<input type="checkbox"/> Minor – Preliminary/Final Plat (Form S2)	<input type="checkbox"/> Sidewalk Waiver (Form V2)	
SITE PLANS	<input type="checkbox"/> Waiver to IDO (Form V2)	APPEAL
<input type="checkbox"/> DRB Site Plan (Form P2)	<input type="checkbox"/> Waiver to DPM (Form V2)	<input type="checkbox"/> Decision of DRB (Form A)
BRIEF DESCRIPTION OF REQUEST		
DRB sign-off for EPC approved Site Plan.

**CARE CENTER (MORTUARY & CREMATORIUM)
3300 VASSAR DRIVE NE
SITE PLAN**

Re: 3300 Vassar Dr. NE (SI-2021-01685, RZ-2021-00045) Final Site Plan Sign-off

The purpose of this letter is to transmit the Site Plan that was approved by the Environmental Planning Commission (EPC) on November 18, 2021. The EPC placed the following conditions of approval. The response to each of the conditions are shown below.

PROPOSED ELEVATIONS

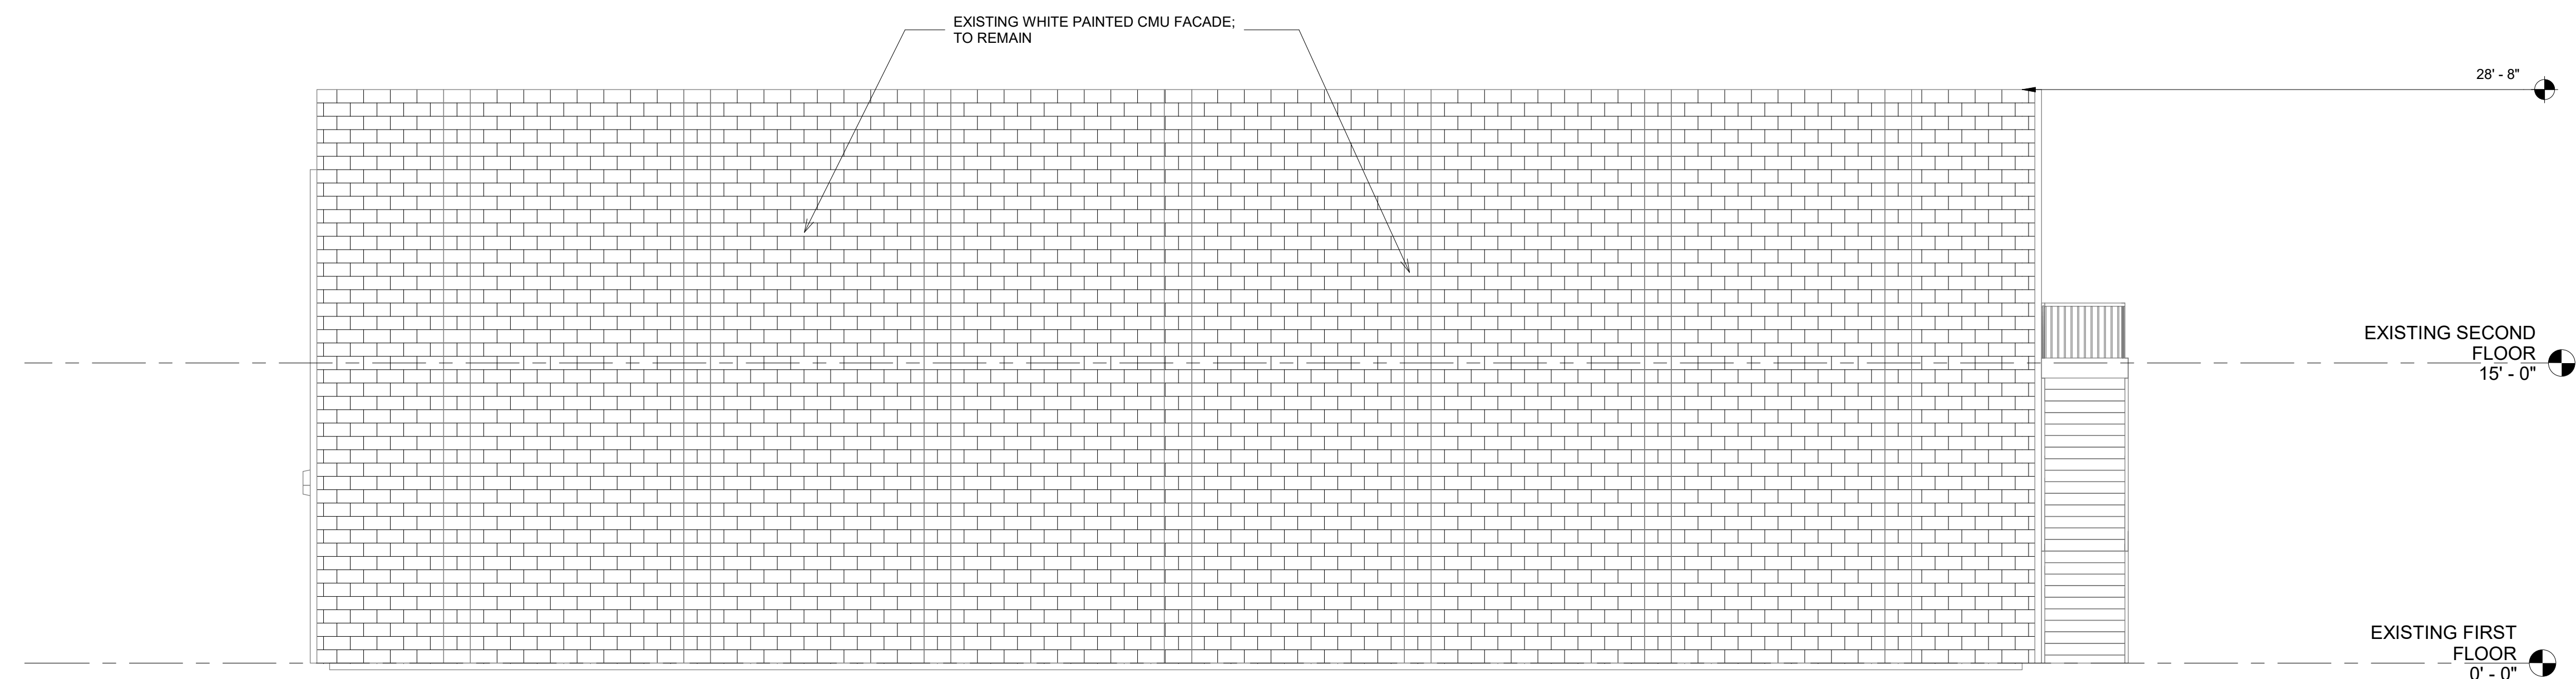
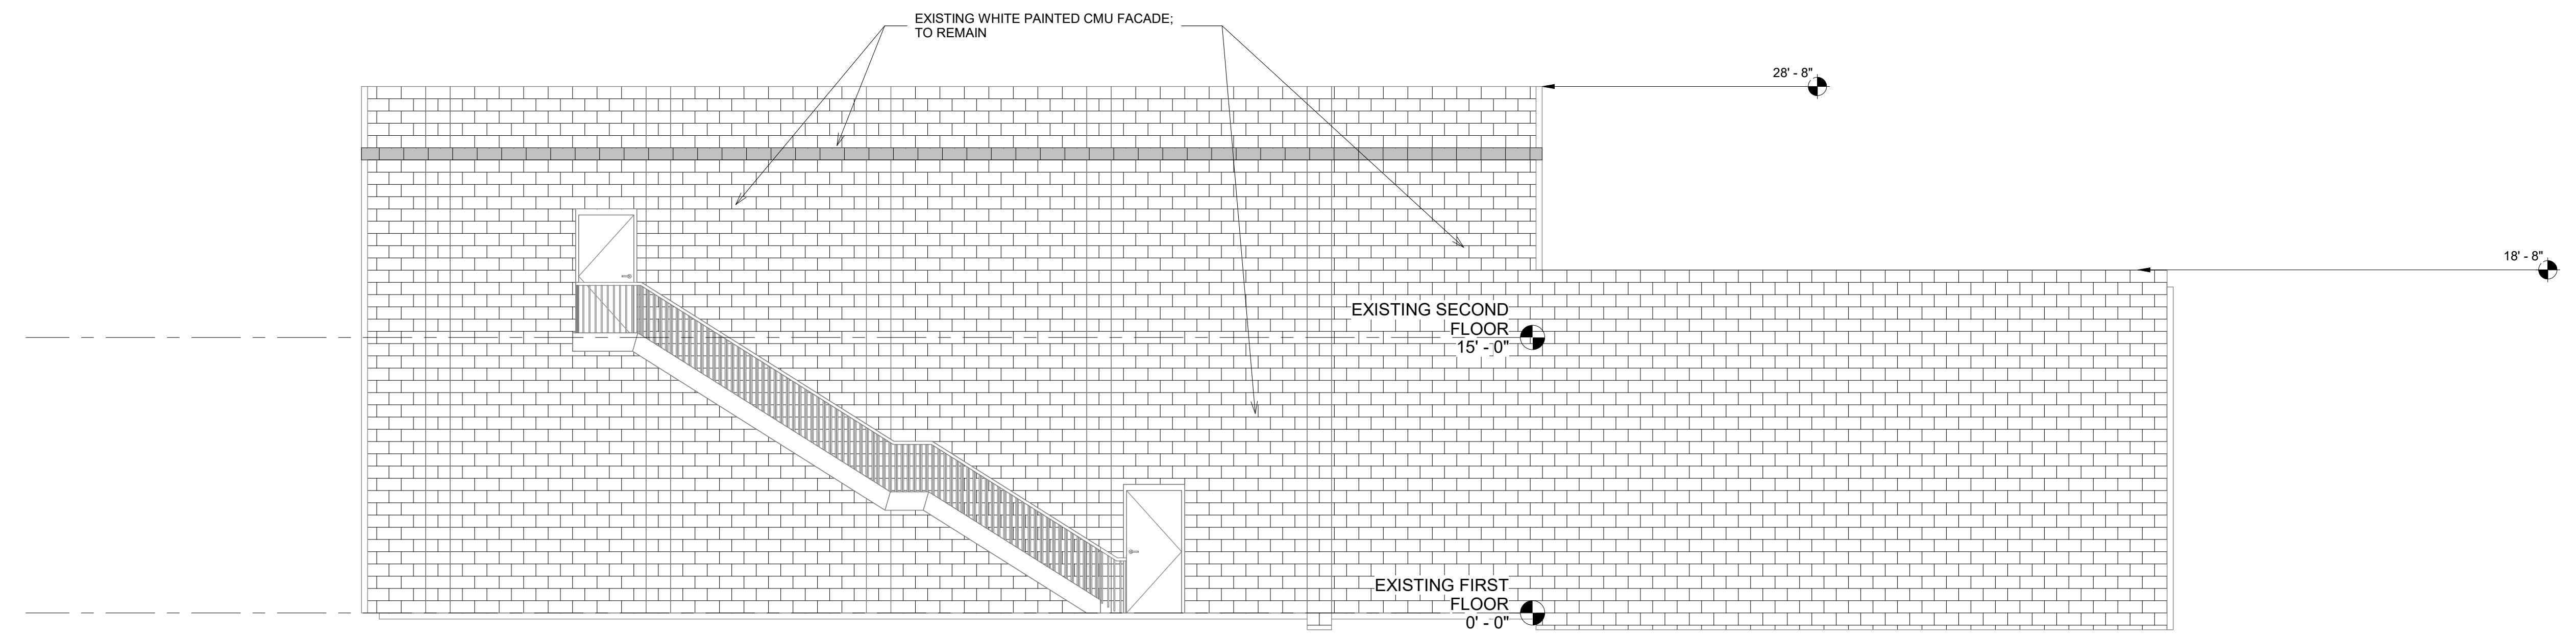
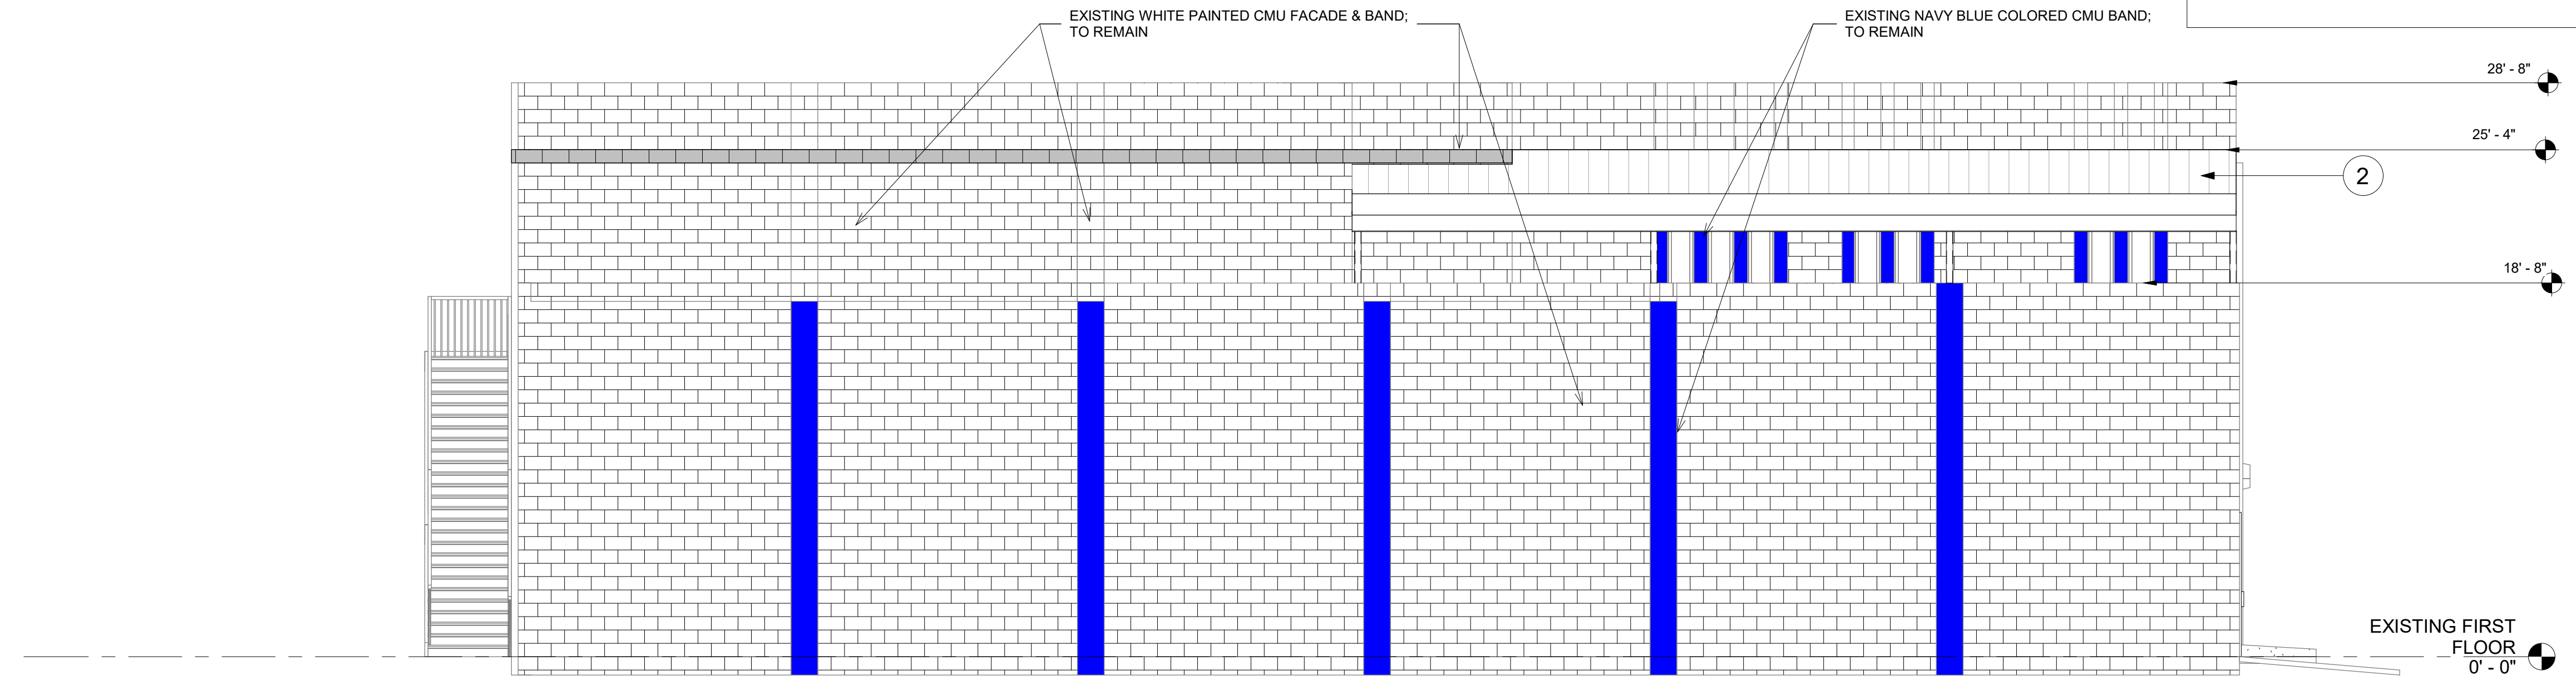
22. Elevations: Complete elevation drawings shall be provided, to include any intended changes to the façade as part of the proposed tenant improvements.

24. Elevations: Accurate building heights shall be shown on all elevations to determine compliance with proposed dimensional standards pursuant to IDO section 5-1(E)(2)(b) – Dimensional Standards, NR-SU Zone District.

25. Elevations: Building color and materials shall be clearly identified.

Sheets 3 and 4 of the Site Plan provide the proposed east, west, south, and north elevations of the building with dimensions.

Additional building dimensions have been provided on all of the elevations shown on Sheets 3 and 4 and are reflected in the dimensional standards table added to the Site Plan – Sheet 1.

The building colors and material have been identified on all elevations shown on Sheets 3 and 4.

1 PROPOSED WEST ELEVATION
3/16" = 1'-0"

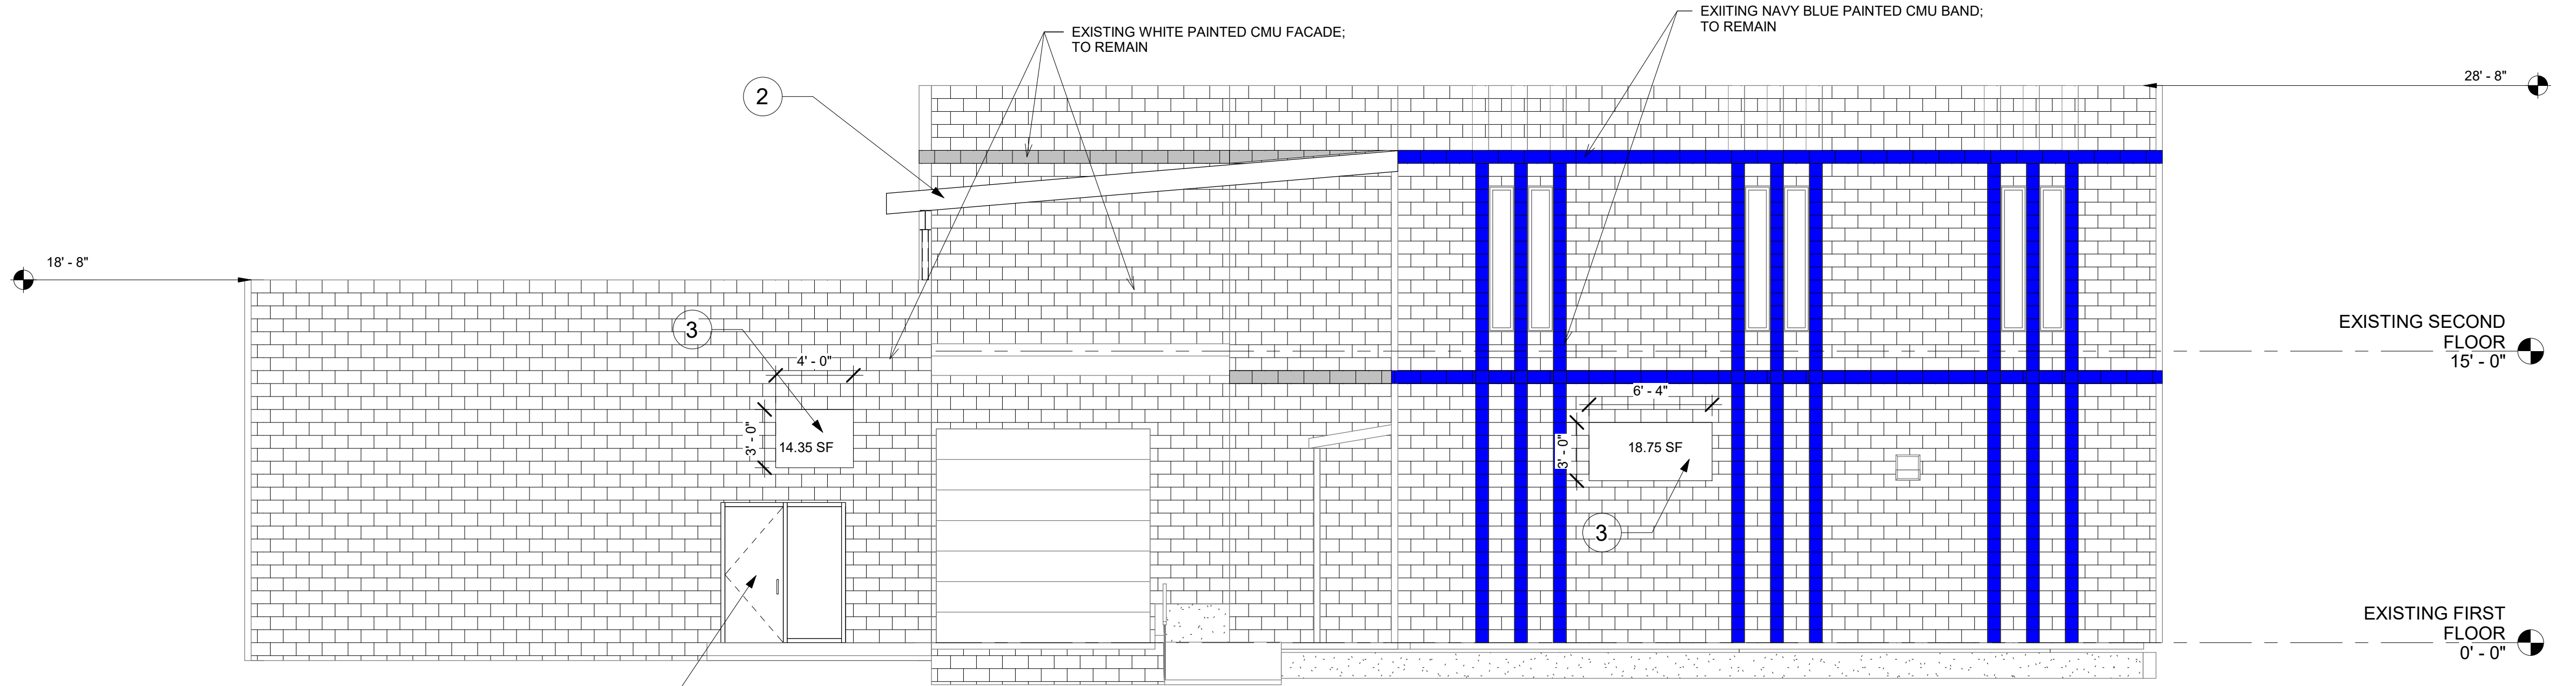
23. Elevations: The proposed porch cover shall be shown on the west elevation, and any other relevant views.

27. Elevations: Pursuant to IDO table 5-12-2, all signage for NR-SU is per approved plan. Proposed signage shall be shown on relevant elevation drawing for the EPC's review, and to establish signage standards.

The west elevation includes the porch cover on Sheet 4.

The existing sign dimensions have been indicated on the proposed west elevation. All signage upgrades will utilize the existing signs dimensions and locations. An additional sign table has been added.
